ARCHITECTURAL REVIEW BOARD STAFF REPORT

Project #/Name	ARB-2024-51: Holly Hills Apartments – Initial
Review Type	Initial Site Plan
Parcel Identification	04600-00-00-028A0, 04600-00-00-028B0, 04600-00-00-028E0, 04600-00-00-028F0, 04600-00-00-028I0, 04600-00-00-028J0, 04600-00-00-028K0, 04600-00-00-028L0
Location	East side of Rt. 29, south of South Hollymead Dr. (See Figures 1 and 2.)
Zoned	Planned Residential Development (PRD) / Entrance Corridor (EC)
Owner/Applicant	Frances B & Willard Howard Birkhead Family Trust Etal (46-28B,46-28I, 46-28J, 46-28K), Old Palmyra Hotel LLC (46-28F, 46-28L), Rebecca Wall (46-28E), Cynthia T Zoulis 46-28A / Collins Engineering (Scott Collins)
Magisterial District	Rivanna
Proposal	To construct a residential development in three phases with approximately 318 apartments in 6 buildings and 72 townhouses in 14 blocks, with associated site improvements.
Context	The properties are either occupied by houses and associated outbuildings or are vacant. The Forest Lakes neighborhood, with a mix of single-family attached and detached dwellings, is located to the east and southeast. The Brookhill development is situated to the south across Ashwood Blvd. Forested

Figure 4: Proposed site layout (with apartment building #s highlighted).

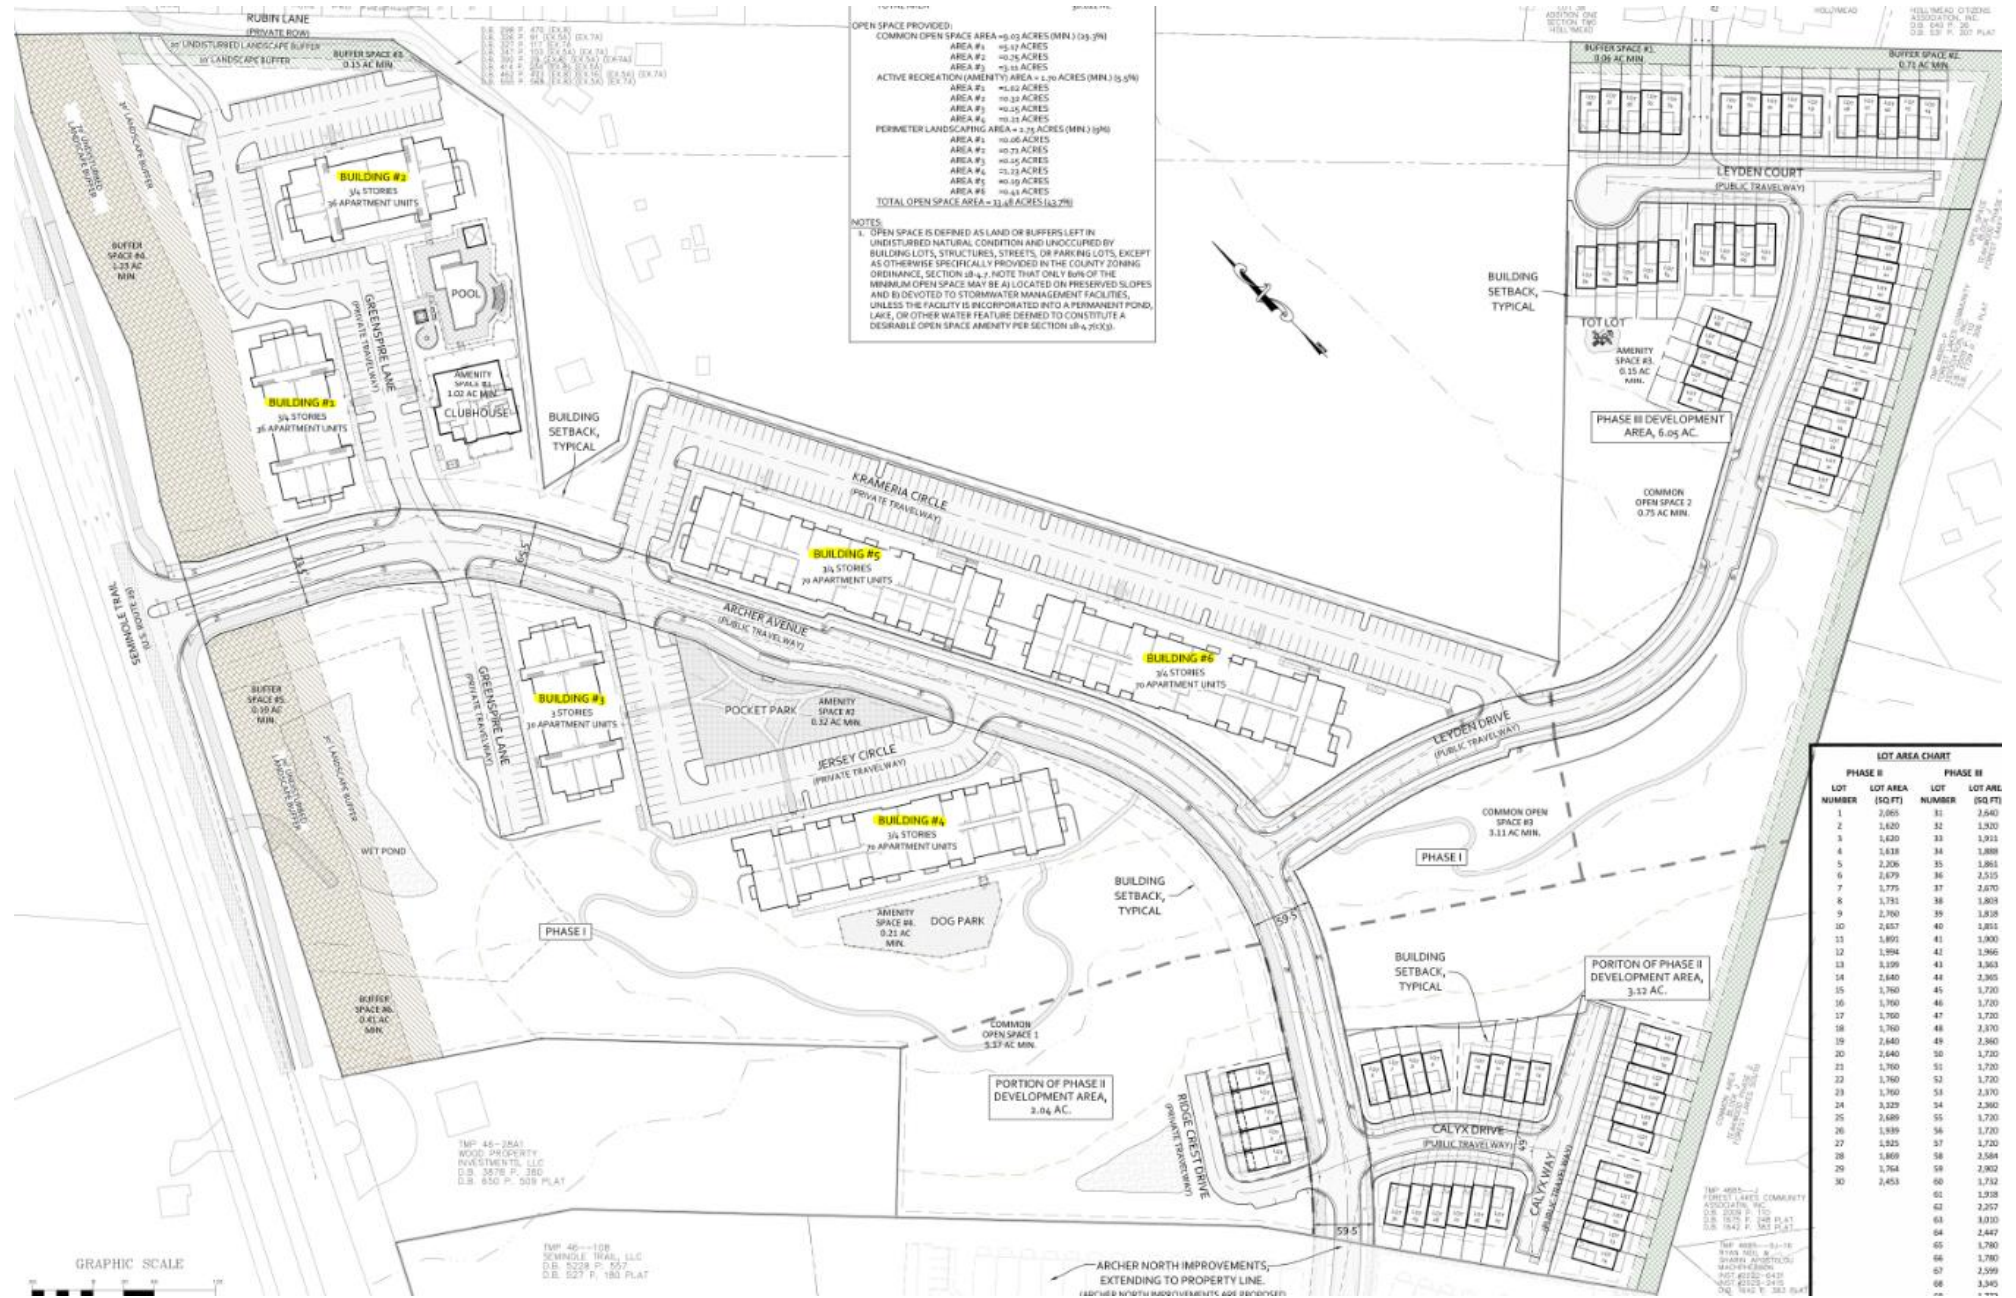
34	<p>Landscaping along interior pedestrian ways:</p> <p>a. Medium trees should be planted parallel to all interior pedestrian ways. Such trees should be at least 2½ inches caliper (measured six inches above the ground) and should be of a species common to the area. Such trees should be located at least every 25 feet on center.</p>		<p>Show pedestrian trees (2½” caliper, 25’ on center) along the sidewalks beside the apartment buildings.</p>
35	<p>Landscaping of parking areas:</p> <p>a. Large trees should align the perimeter of parking areas, located 40 feet on center. Trees should be planted in the interior of parking areas at the rate of one tree for every 10 parking spaces provided and should be evenly distributed throughout the interior of the parking area.</p> <p>b. Trees required by the preceding paragraph should measure 2½ inches caliper (measured six inches above the ground); should be evenly spaced; and should be of a species common to the area. Such trees should be planted in planters or medians sufficiently large to maintain the health of the tree and shall be protected by curbing.</p> <p>c. Shrubs should be provided as necessary to minimize the parking area’s impact on Entrance Corridor streets. Shrubs should measure 24 inches in height.</p>	<p>It is expected that portions of the parking areas north and west of Building 2 and east and west of Building 3 will be visible until the trees in the 30’ landscaping buffer are established and mature. Therefore, sufficient parking lot trees are necessary to mitigate visibility from the EC.</p> <p>Shrubs are not expected to have a significant visual impact as viewed from the EC.</p>	<p>Show perimeter trees (2½” caliper, 40’ on center) along the north, west, and south sides of the parking lots near Buildings 2 and 3.</p>

37	Plant species: a. Plant species required should be as approved by the Staff based upon but not limited to the <i>Generic Landscape Plan Recommended Species List</i> and <i>Native Plants for Virginia Landscapes (Appendix D)</i> .	A landscape plan has not been provided with the initial site plan submittal.	Provide a complete plant schedule on the landscape plan. Include only plant species found on the approved plant lists.
38	Plant health: The following note should be added to the landscape plan: “All site plantings of trees and shrubs shall be allowed to reach, and be maintained at, mature height; the topping of trees is prohibited. Shrubs and trees shall be pruned minimally and only to support the overall health of the plant.”	The note does not appear on the plan.	Add the standard plant health note to the plan.
Site Development and layout, Development pattern, Site Grading			
6	Site development should be sensitive to the existing natural landscape and should contribute to the creation of an organized development plan. This may be accomplished, to the extent practical, by preserving the trees and rolling terrain typical of the area; planting new trees along streets and pedestrian ways and choosing species that reflect native forest elements; insuring that any grading will blend into the surrounding topography thereby creating a continuous landscape; preserving, to the extent practical, existing significant river and stream valleys which may be located on the site and integrating these features into the design of surrounding development; and limiting the building mass and height to a scale that does not overpower the natural settings of the site, or the Entrance Corridor.	<p>Much of the existing natural landscape will be lost with the proposed development. New grading and retaining walls are not limited; a significant amount of grading and retaining walls are proposed to accomplish the development. Contours are rounded throughout the site; however, top-of-wall and bottom-of-wall notes indicate a retaining wall height of 15’ between Building 3 and the EC. This wall is not terraced and is expected to be highly visible from the EC. Terracing and planting this wall to help integrate it into the surrounding context would be appropriate.</p> <p>The proposal includes a new site entrance from Rt. 29 and a public travelway connecting at the southern property line to Archer Ave. This would complete the connection (proposed under a separate site plan) to Ashwood Blvd. The layout of buildings along the travelways is generally organized. Sidewalks are provided along the primary travelways and connect with existing sidewalks on Rt. 29 and the proposed sidewalks in the development to the south. Buildings 1-4 have elevations parallel to the EC, two with their long elevations and two with their short elevations. The appearance along the EC will change significantly with this development, but there are currently no significant views from the street that will be affected.</p>	Revise the site plan to show the retaining wall between the frontage and Building 3 terraced and landscaped.

1. The anticipated short-term and long-term visibility of the proposed apartment buildings.
2. The anticipated visibility of the townhouse blocks.
3. Landscaping: The need for EC frontage trees, perimeter parking lot trees, and trees along sidewalks.

11. Show street trees (3½" caliper, 35' on center) on the east side of the shared-use path along the Rt. 29 frontage.
 12. Show interior road trees (2½" caliper, 40' on center) along the public travelways within the site.

13. Show pedestrian trees (2½" caliper, 25' on center) along the sidewalks beside the apartment buildings.
 14. Show perimeter trees (2½" caliper, 40' on center) along the north, west, and south sides of the parking lots near Buildings 2 and 3.

17. Revise the site plan to show the retaining wall between the frontage and Building 3 terraced and landscaped.
18. Maintain grading outside the driplines of trees to remain. Show tree protection fencing for the trees to remain in the 30' buffer on, and coordinated throughout, the grading, landscaping, and erosion and sediment control plans.
19. Replace the chain link fence around the VDOT stormwater facility with a material that has less negative visual impact. If existing chain link fencing is to remain, revise the site plan to show it.
